THE GIBSON

3421 & 3422 WOODLAND PARK
AVE N, SEATTLE WA
3032609-EG
3029623-LU

RECOMMENDATION

MEETING: MONDAY, NOVEMBER 23RD, 2020

^ EDG Diagram of Massing Articulation

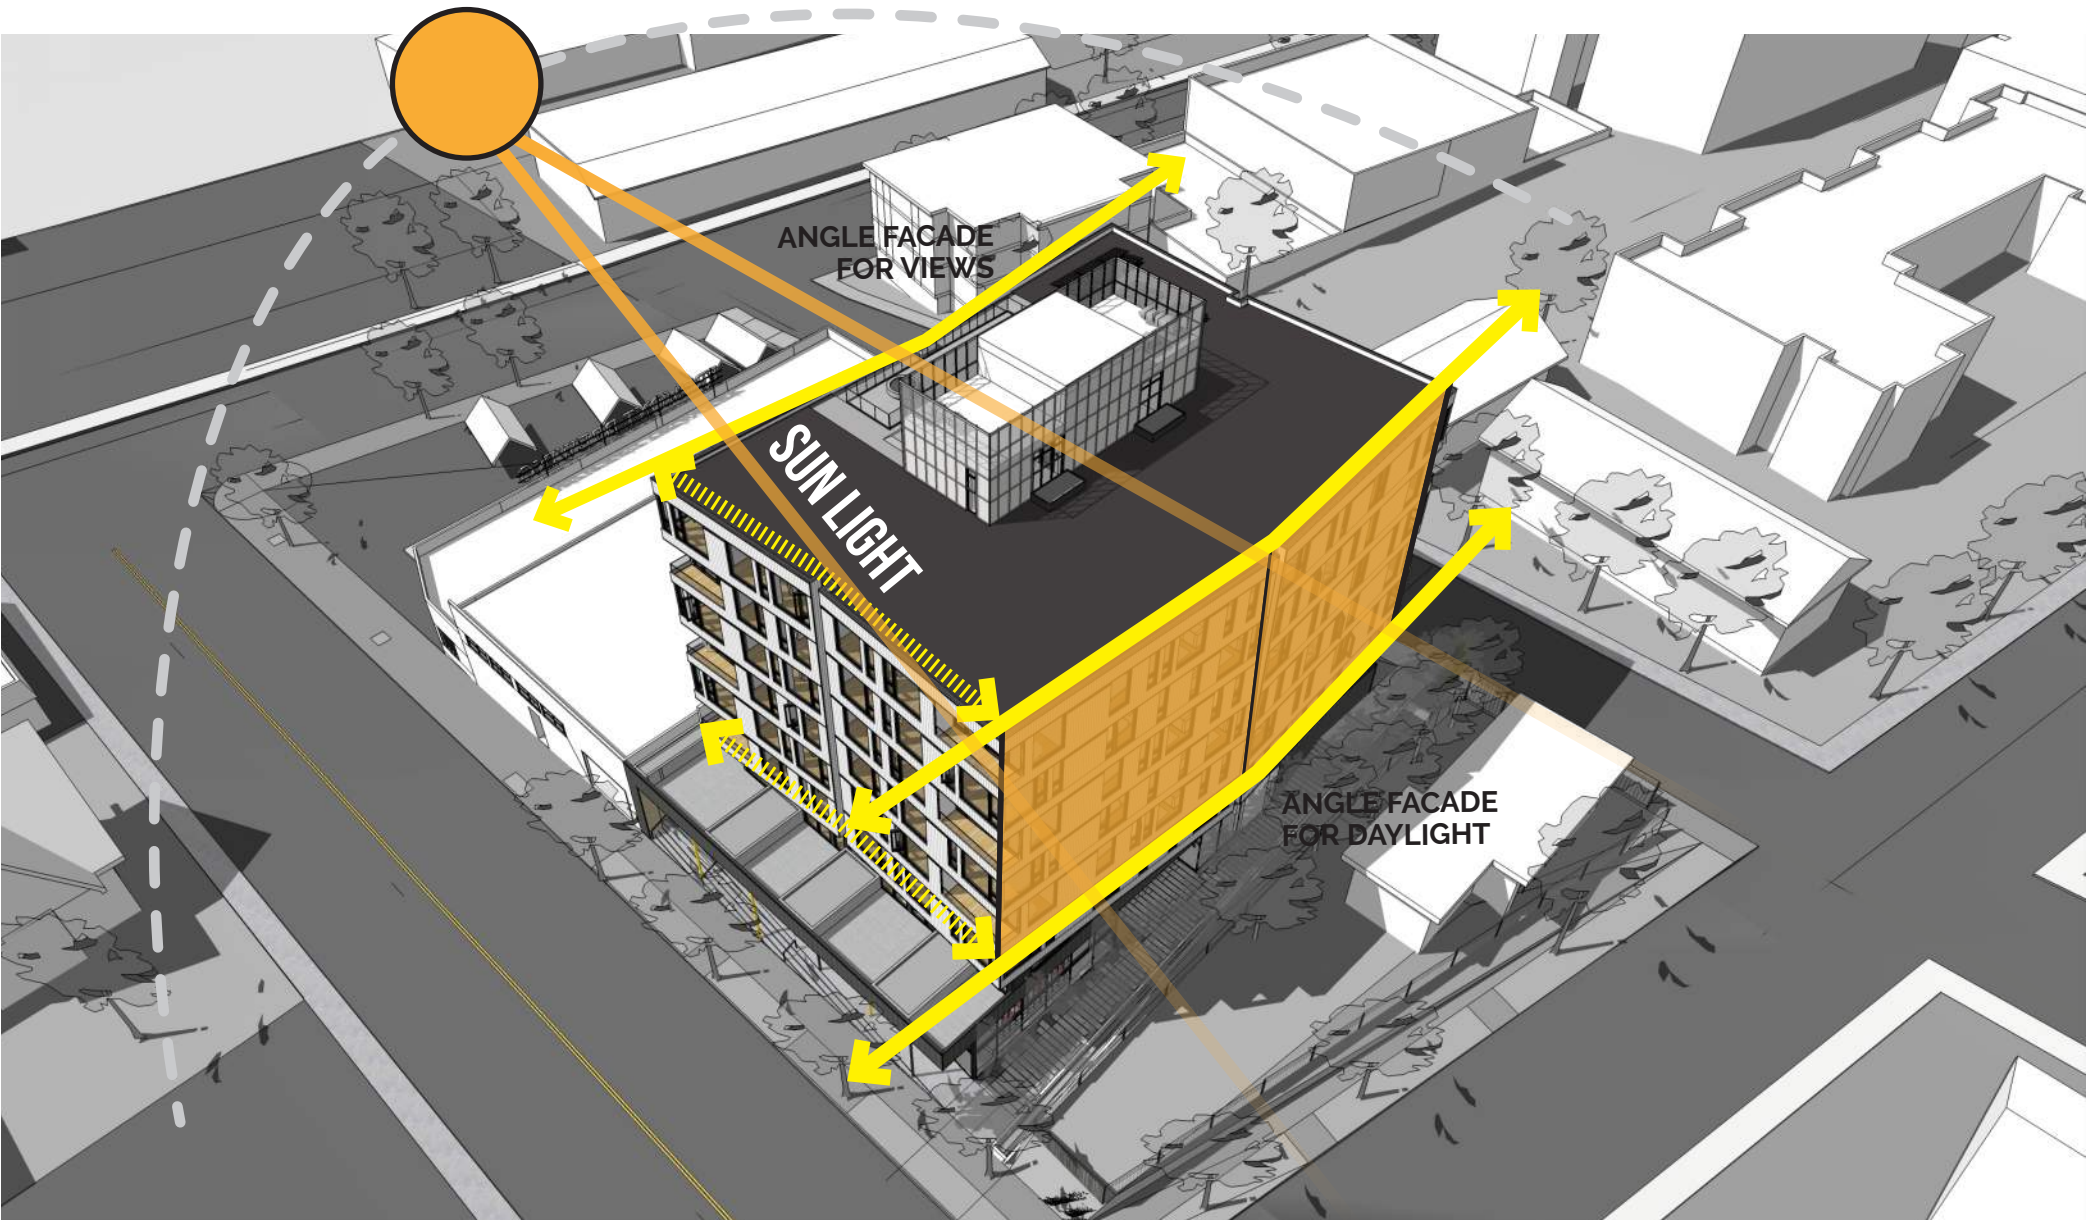
- a. The Board unanimously supported Option B3, the applicant's preferred massing option, as it is highly responsive to the present and future context, neighboring structures, and unique perimeter conditions. (CS2)

- b. The Board supported the subtle and sophisticated sculpting of Option B3, and stated it appears to be light and fun in comparison to the blocky and conventional form of options B1 and B2. In agreement with public comment, the Board encouraged further development of the overall architectural character in a manner that expresses the whimsy and quirkiness of the Fremont neighborhood and specifically prioritized Design Guideline CS2-A, Location in the City and Neighborhood, and CS3A, Emphasizing Positive Neighborhood Attributes. (CS2-A, CS3-A)

The massing scheme from the EDG has been maintained and the angular shape of the massing is preserved in order to provide sunlight to the north neighbor and create opportunities for views along the south. Additionally, the angular shape and sculptural form of the building enhance the artistic vibes of the Fremont neighborhood allowing the building to establish a sense of place along the neighborhood block. CS2-A (Sense of Place and Architectural Presence)

^ EDG Diagram of Massing Articulation

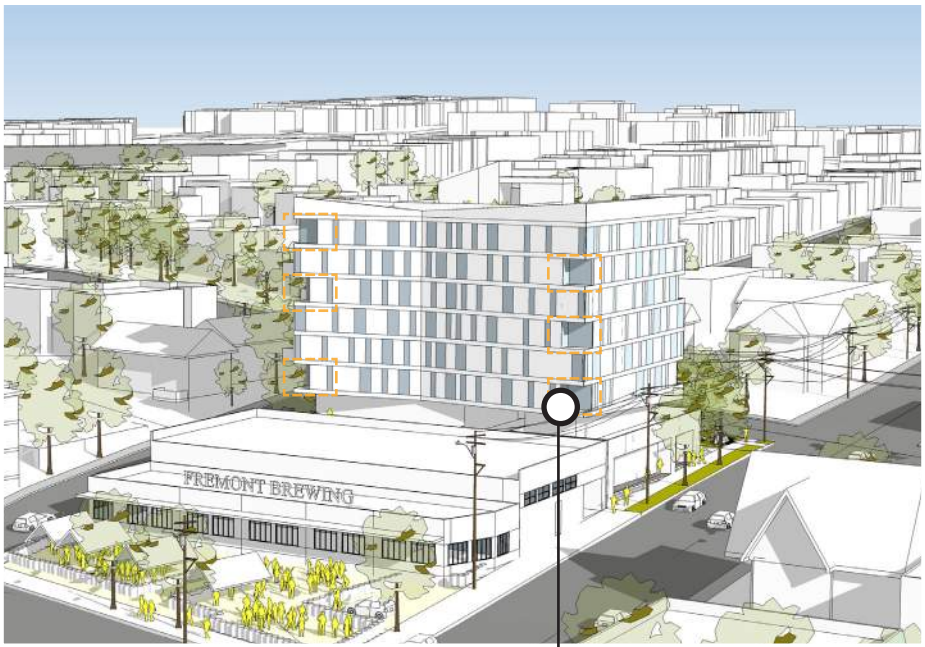
c. In agreement with public comment, the Board supported the eroded corners concept. The Board noted this feature is important to the success of the mass and should be expanded upon – see additional guidance below under #4.a. (DC2)

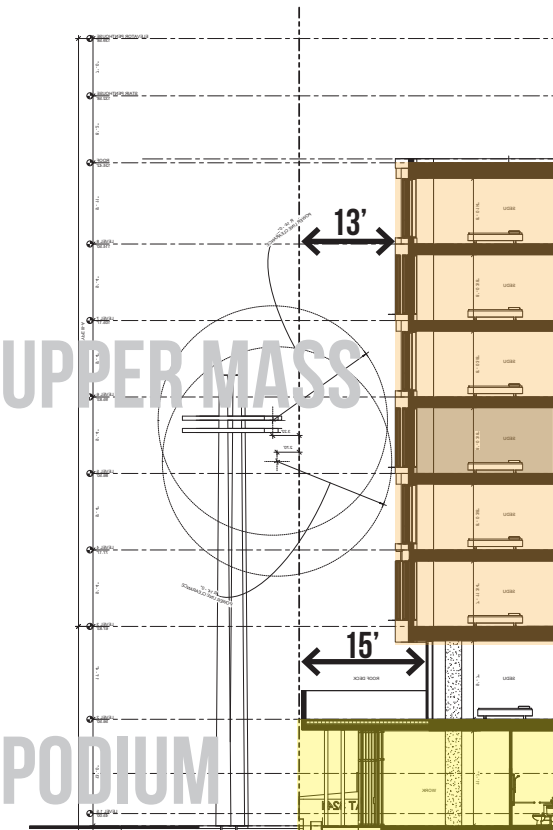
- e. The Board supported the response to the existing commercial datum to the south along Woodland Park Ave N and the resulting upper-level setback above the live/work units. (CS2-B, CS3-A-1, DC2-A-1)
- f. The Board specifically prioritized PL3-A, Entries, and PL3-B, Residential Edges. (PL3A,PL3-B)

Ground Floor Plan
Scale: NTS

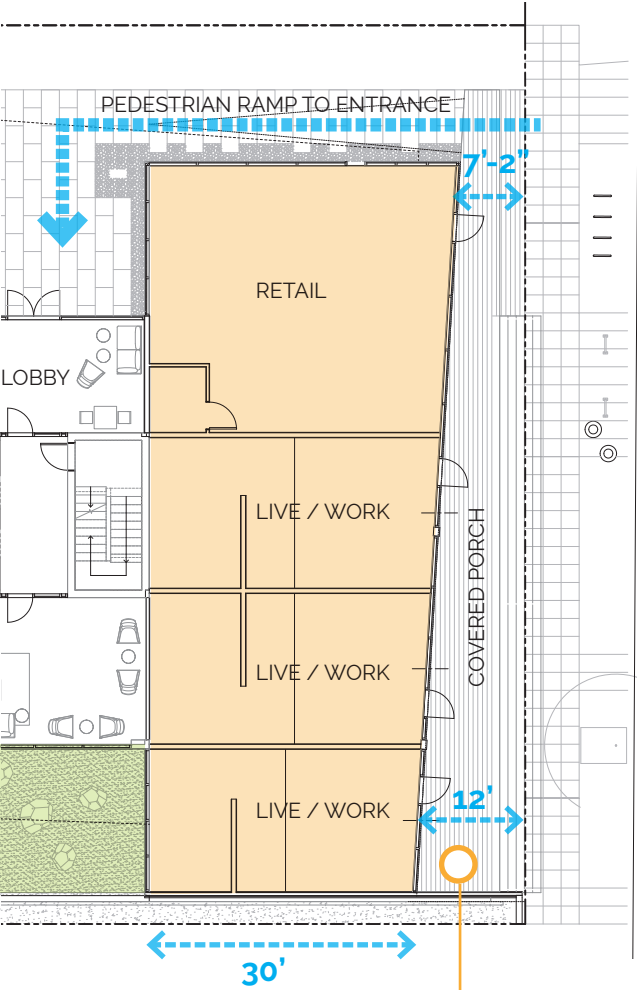
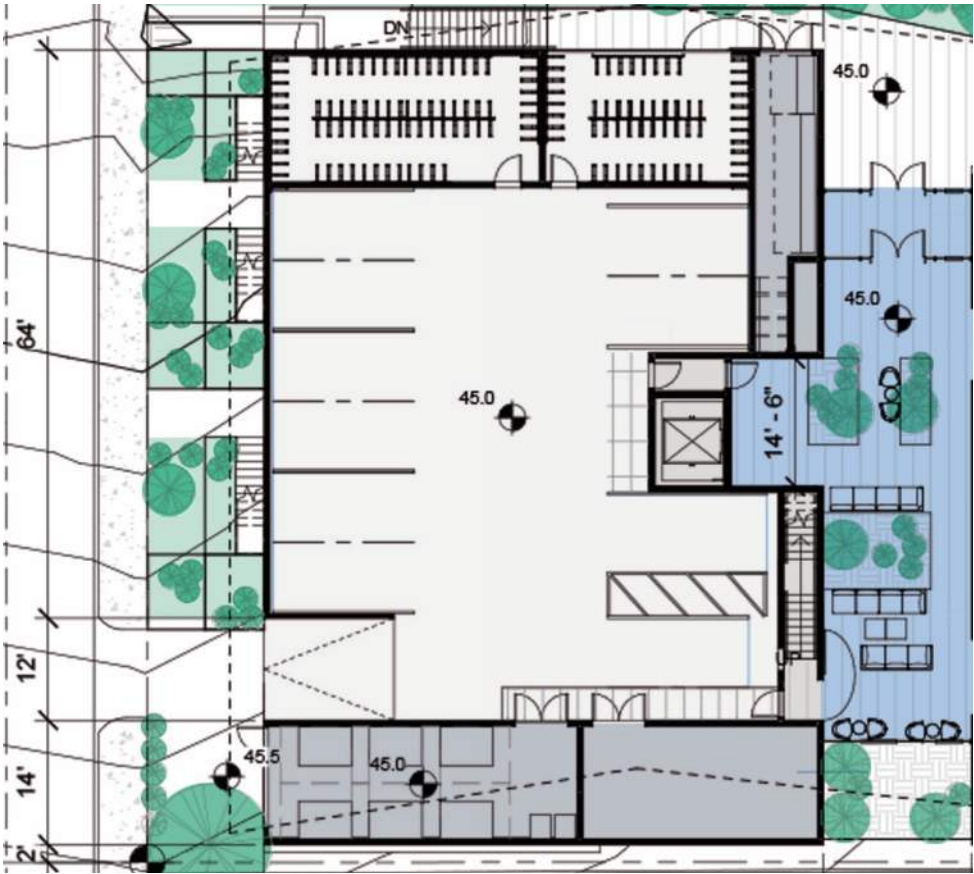
The board supported the location of the live/work units and the transition between existing commercial use and the residential use. The board provided guidance to contribute to the pedestrian realm.

The proposed location of the live/work units and retail program have been maintained at the northeast corner of the site providing a good transition between the existing commercial spaces on the north and south and the new residential structure.

To enhance the sense of pedestrian activation along these units, an angle was created (*akin to the angles along the upper level mass*) along the ground plane that expands the depth of the covered porch area under the building overhang. This area will allow for spill out space and informal gathering opportunities along Woodland Park Ave N.

The live/work unit depths have been re-configured to ensure the 30' required commercial depth (15' min for the business portion of the unit), so no departure is needed, though the secondary entrances from the west have been eliminated in an effort to provide needed egress and exiting and a courtyard space off the south lobby.

^ EDG Diagram of Albion Place N Residential Entries, Vehicular and Solid Waste Storage Access

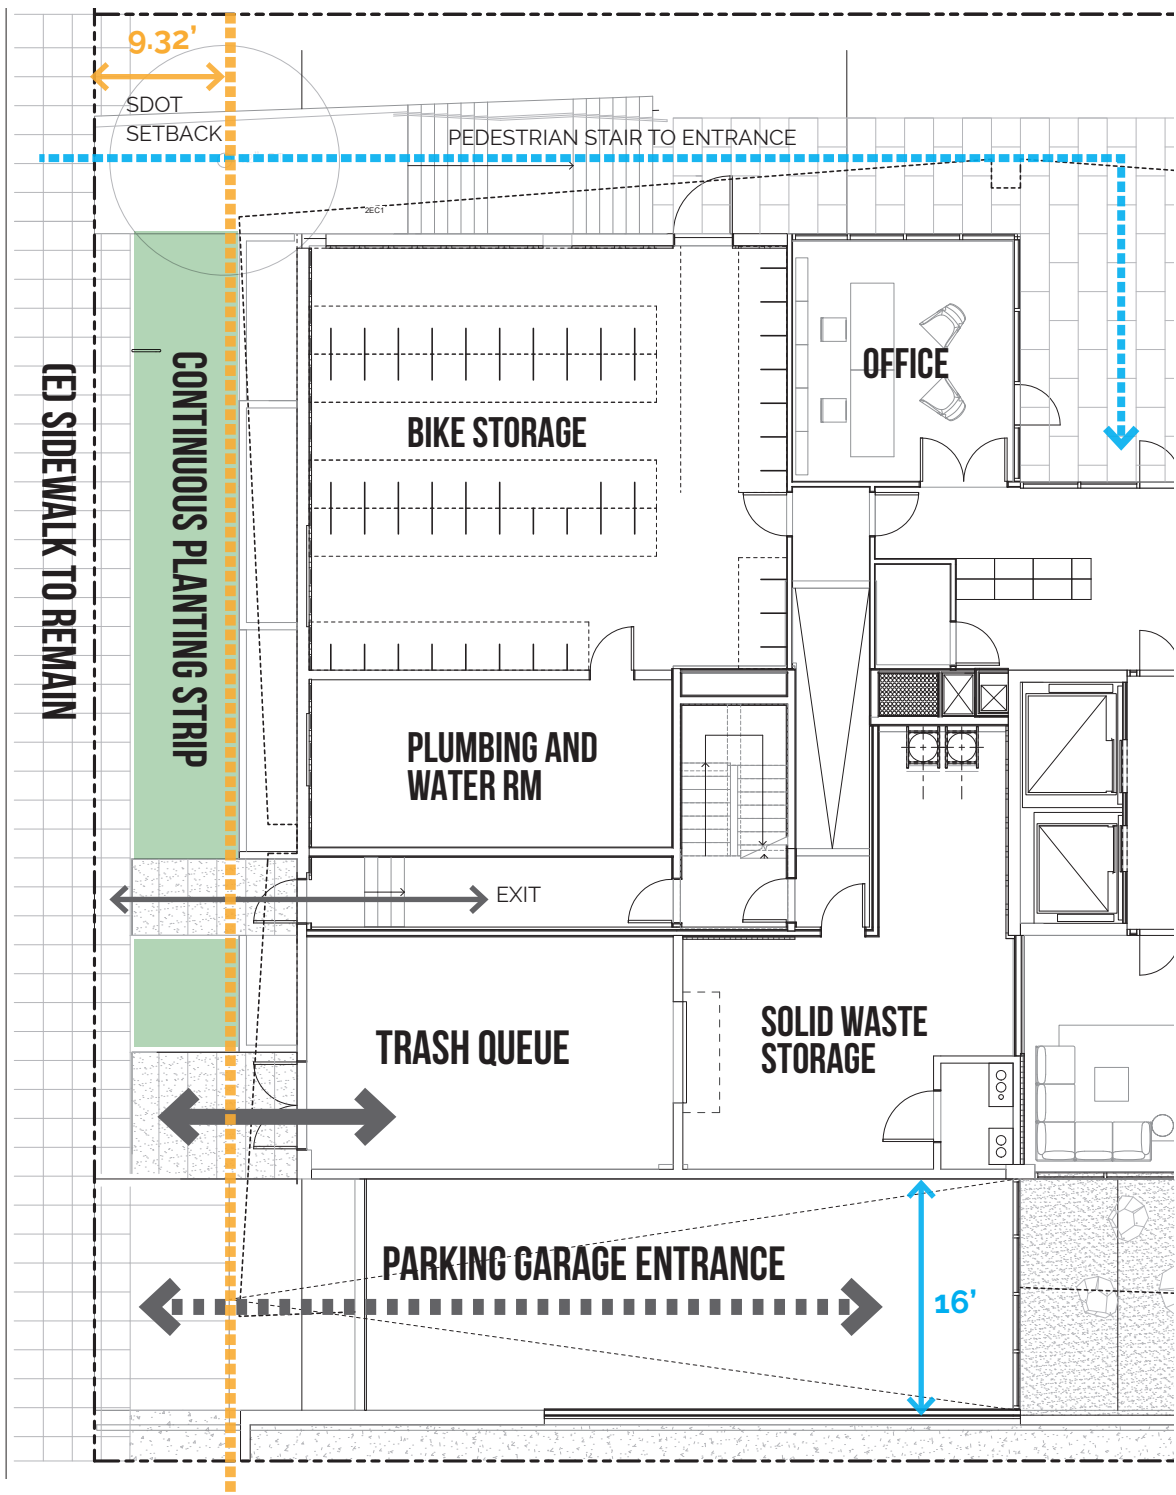
- a. The Board supported the proposed individual entries along Albion Place N as it maximizes eyes on the street. Stoops should be designed to be usable spaces and contribute to a residential character. (PL2-B-1, PL3-A-3, PL3-B, DC2-D-1)
- b. The Board acknowledged SDOT comments regarding the preferred planting strip location along Albion Place N; however, the Board noted that locating the sidewalk between the curb and the planting strip helps buffer residential units by creating a more contiguous landscape along the property line. (PL3-B, DC4-D-1)
- c. The Board supported the proposed trash storage, staging and service plans. (DC1-C)

- a. The design team evaluated the program with the client and consultant team following the Early Design Guidance meeting and determined that the ground level needed to be slightly modified in order to accommodate some additional bike storage and plumbing / mechanical rooms. Keeping with the idea of preserving the commercial base datum, the design was adapted to maintain the commercial look around the base of the structure, with landscaping and access doors for trash and the parking garage.

- c. Per design guideline PL1-A1 "Enhancing open space" the existing sidewalk condition has been left in its original place to maintain the traditional block condition and more meaningfully connect to the broader open space network that is existing. All pedestrian access has been designed to integrate with this condition and the design team agrees with SDOT regarding the larger, continuous planting strip adjacent to the building.

v Precedent Images from EDG packet

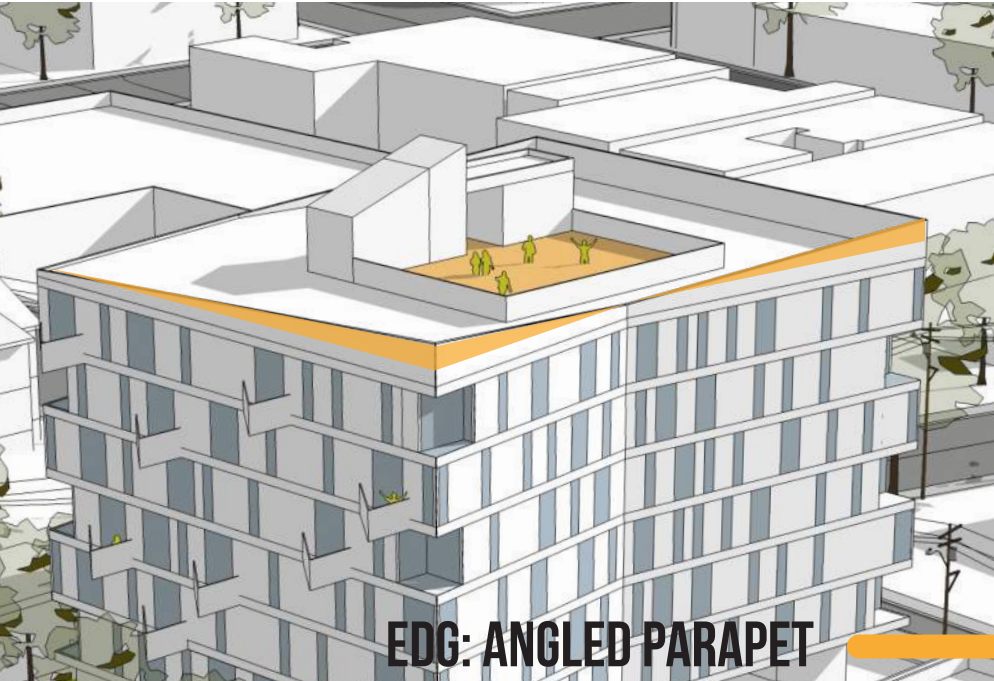
C. In agreement with public comment, the Board supported the continuous horizontal banding. The Board noted that banding should be achieved through figure/ground composition of glazing and materials, as depicted in precedent images 1 and 3 on page 35 of the EDG Packet, rather than literal horizontal material striping, as depicted in precedent image 4 on the same page. (DC2-B-1)

Response: As the design developed, the design team followed guidance to provide for a continuous horizontal design language as emphasized below on the podium and through the banding in the main white metal mass. While the darker base materials weight and ground the building, the dark windows were picked up at the top to compose the fenestration within the figure / ground methodology proposed, helping break up and further define the window openings.
